SERVICE BULLETIN REVISION TRANSMITTAL SHEET

MODEL BD-100-1A10 (CH-350)

Service Bulletin No.	<u>350-23-011</u>		
Date of Basic Issue	<u>Jun 25/2014</u>		
Revision No.	<u>01</u>	Dated	<u>May 31/2016</u>
Revision No.	<u>02</u>	Dated	<u>Nov 30/2017</u>
Revision No.	<u>03</u>	Dated	<u>Mar 07/2018</u>
Revision No.	<u>04</u>	Dated	<u>Jan 30/2023</u>
Revision No.	<u>05</u>	Dated	<u>Aug 10/2023</u>
Revision No.	<u>06</u>	Dated	<u>Dec 19/2024</u>

MODIFICATION – COMMUNICATIONS – INTRODUCTION OF FUTURE AIR NAVIGATION SYSTEM (FANS) 1/A+ OPTION (C23-600)
--

RIU 1 Connector A17P2 – Removal/Installation
Figure 1

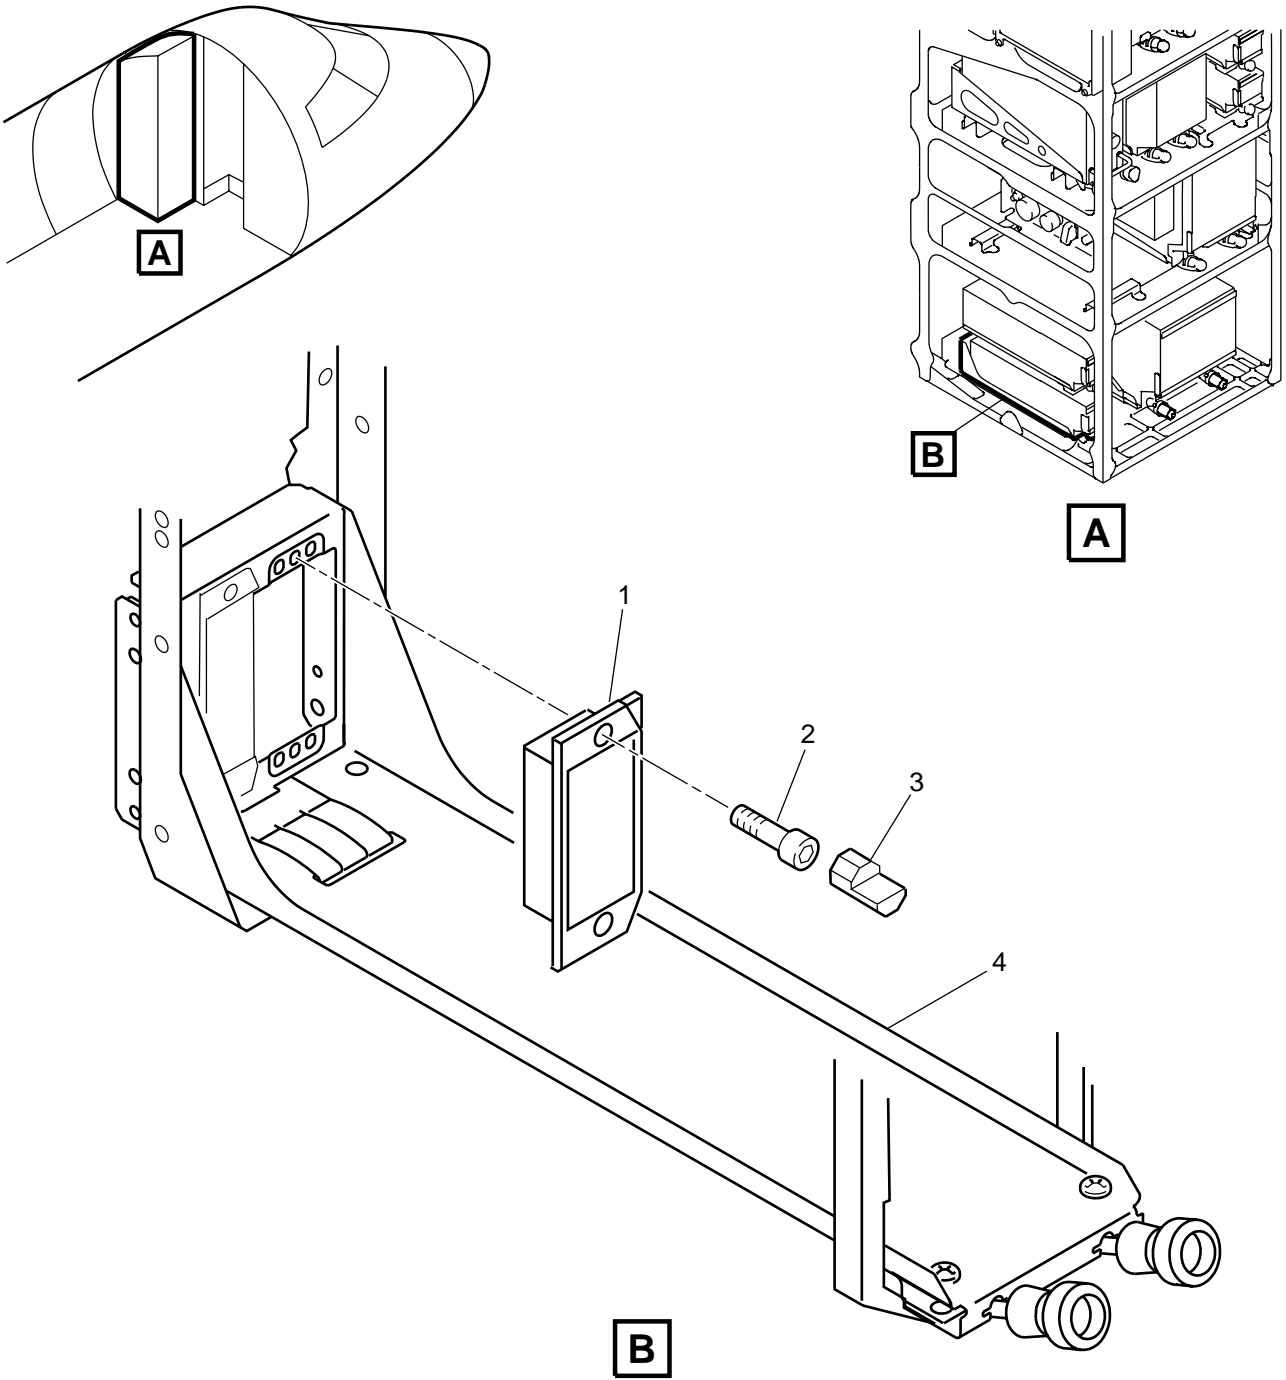
- (1) In the left equipment rack, remove the RIU 1 connector A17P2 (1) from the RIU tray (4) as follows. Refer to Figure 1.

- (a) Remove the RIU 1. Refer to AMM 23-51-21-000-801.
- (b) Record the position of the indexing key (3) on the connector A17P2 (1).
- (c) Remove the indexing key (3).
- (d) Remove the screws (2) and keep for later installation.
- (e) Remove the electrical connector A17P2 (1) from the tray (4).

(c) In the left equipment rack, install the RIU 1 connector A17P2 (1) in the RIU tray (4) as follows. Refer to Figure 1.

(i) Put the electrical connector A17P2 (1) in position on the tray (4).

(ii) Install the screws (2) previously removed.

(iii) Torque the screws from 13 to 16 lbf in (1.47 to 1.8 Nm). Refer to SPM-MM 20-21-00-910-801.

(iv) Install the indexing key (3) in the same configuration as recorded during removal.

K1002370003 – Kit – Wiring Diagram – CVR/RIU 1 Wiring for FANS 1/A+
(Sheet 1 of 2, Rev. --)

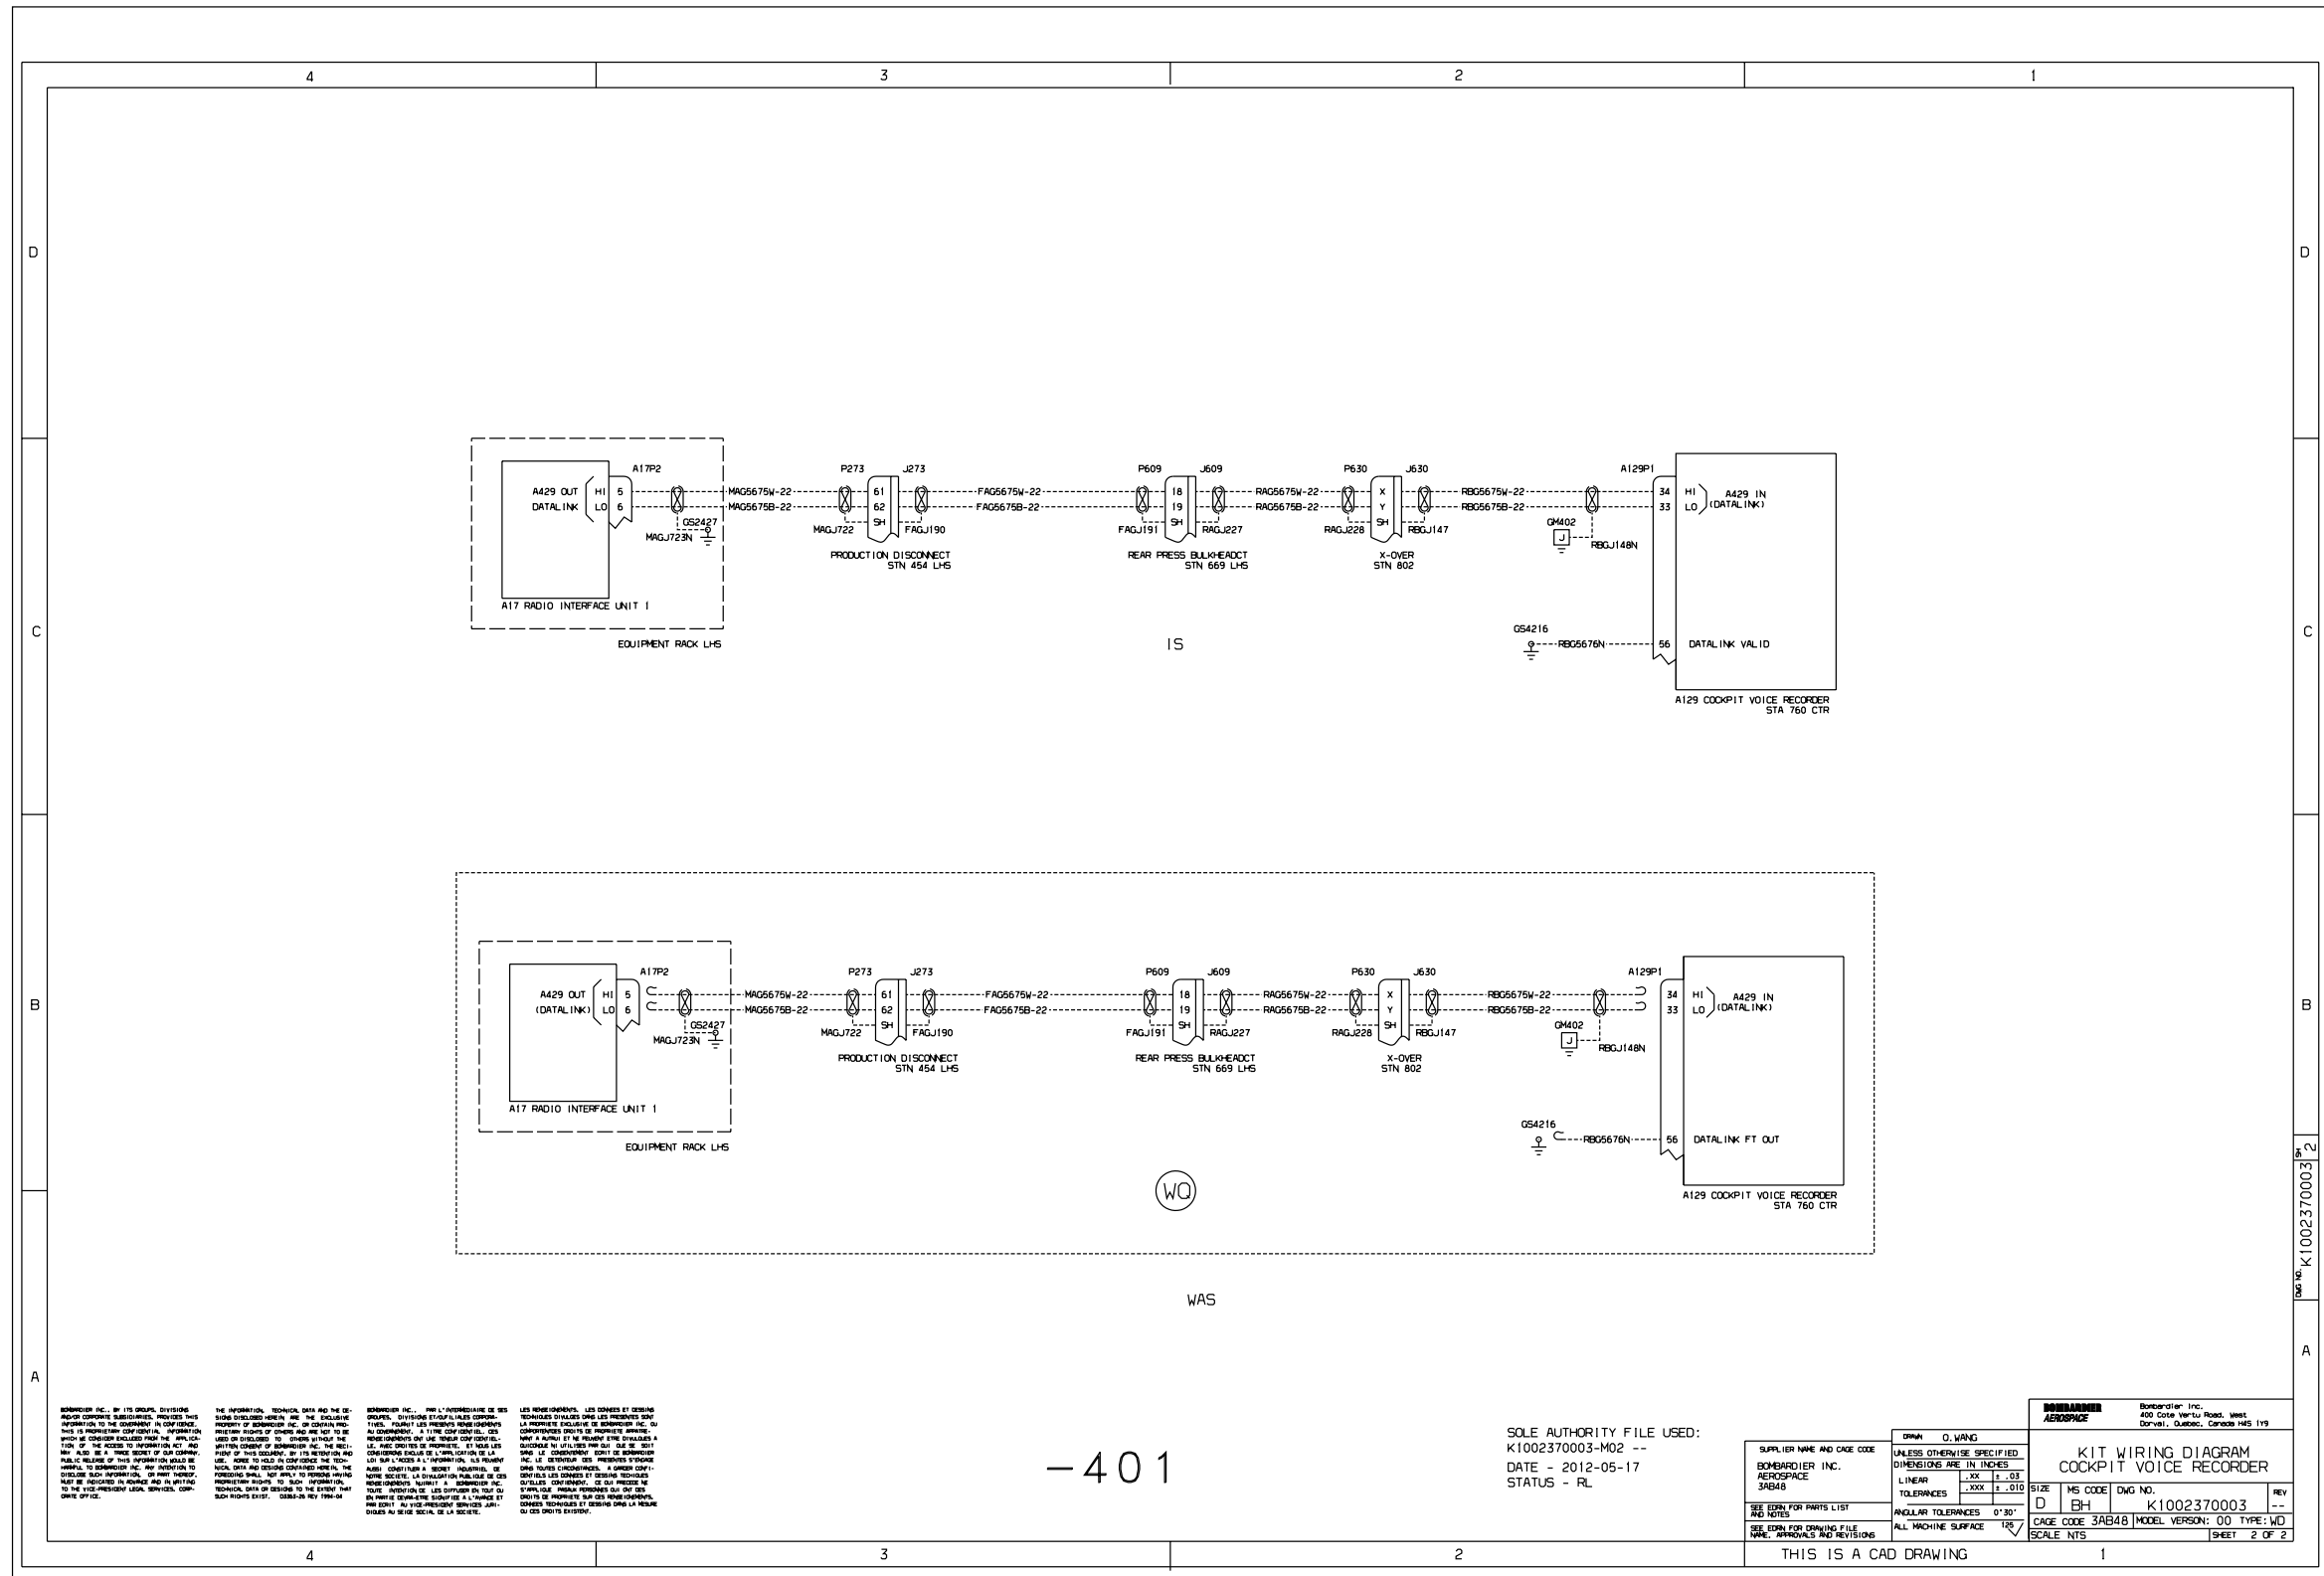
- (a) Connect the CVR wiring to the RIU 1 connector A17P2 as follows. Refer to Kit Drawing K1002370003.

- (i) Unstow and remove the caps from the wire MAG5675W/B.
- (ii) Install contacts Part No. 372-2514-110 on wires MAG5675W and MAG5675B. Refer to SPM-WM 20-21-01.
- (iii) Connect wire MAG5675W to pin 5 of RIU 1 connector A17P2.
- (iv) Connect wire MAG5675B to pin 6 of RIU 1 connector A17P2.

- (b) Connect the RIU wiring to the CVR connector A129P1 as follows. Refer to Kit Drawing K1002370003.

- (i) Remove the CVR. Refer to AMM 23-71-01-000-801.
- (ii) Unstow and remove the caps from the wire RBG5675.
- (iii) Install contacts Part No. 031-9134-001 on wires RBG5675W and RBG5675B. Refer to SPM-WM 20-20-10.
- (iv) Connect wire RBG5675W to pin 34 of CVR connector A129P1.
- (v) Connect wire RBG5675B to pin 33 of CVR connector A129P1.
- (vi) Trim the conduit, Part No. S10155H23 to the correct length and install on the wire RGB5676N.
- (vii) Install terminal lug Part No. B0808005-006N on wire RBG5676N.

(viii) Connect wire RBG5676N to ground stud GS4216, with washer, Part No. AN960JD10L, lockwasher, Part No. MS35338-43 and nut, Part No. MS35650-302. Refer to SPM-MM 51-80-00-910-803.
